# Work Order ID 84913

Item Name: Skidtube RH

# **DART SERVICE INSTRUCTION**

**TO AMEND INSTALLATION INSTRUCTIONS IIN-D209-669 REV. B**

INSTALL TOW RING ASSEMBLY AS SHOWN BELOW (REFER TO SECTION F-F OF IIN-D209-669 REV. B.

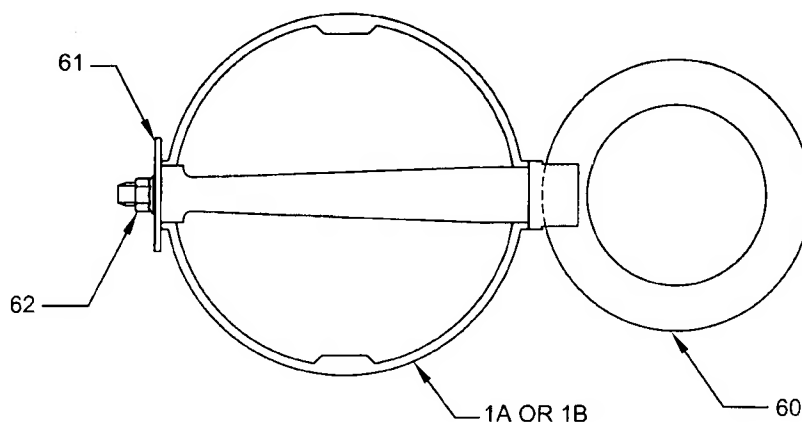
**IS:**

**WAS:**
